Recommended Changes to Optical PMD Proposal

IEEE 802.3z Gigabit Ethernet

November 13, 1996

Figure 2 - SWL Operating Distance Ranges

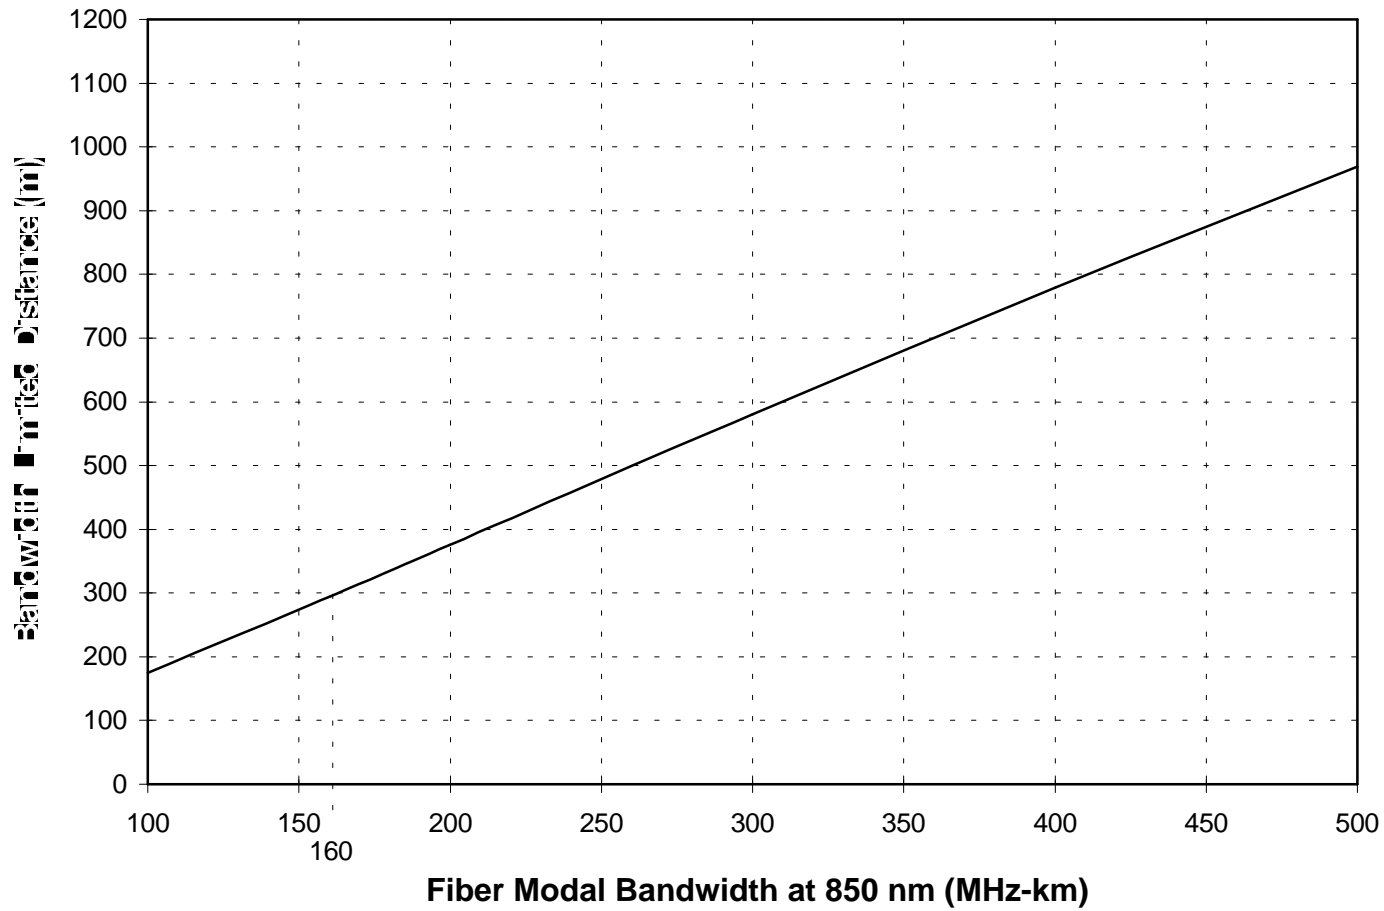
Description	Unit	Value	
		62.5 μm MMF	50 μm MMF
Guaranteed <u>Operating distance (typ)</u>	m	<u>300*</u> (see figure 2) 200	<u>950*</u> (see figure 2) 450
Maximum attenuation @ 850 nm	dB/km	<u>3.5</u> 4.0	3.5
Minimum modal bandwidth @850 nm	MHz-km	160	<u>500</u> 400
Dispersion slope	ps/km-nm ²	<u>see figure 3 0-093</u>	<u>see figure 3 0-105</u>
<u>Zero</u> Min. dispersion <u>wavelength</u> point	μm	<u>see figure 3 1-36</u>	<u>see figure 3 1-33</u>
<u>Modal noise penalty allocation</u>	dB	<u>T.B.D. (see note A)</u>	<u>T.B.D. (see note A)</u>
<u>Dispersion penalty allocation</u>	dB	<u>T.B.D. (see note A)</u>	<u>T.B.D. (see note A)</u>
<u>Maximum link attenuation @ 850 nm</u>	dB	<u>T.B.D. (see note B)</u>	<u>T.B.D. (see note B)</u>

* Final values for distance are dependent on jitter budget and effective optical rise/fall times.
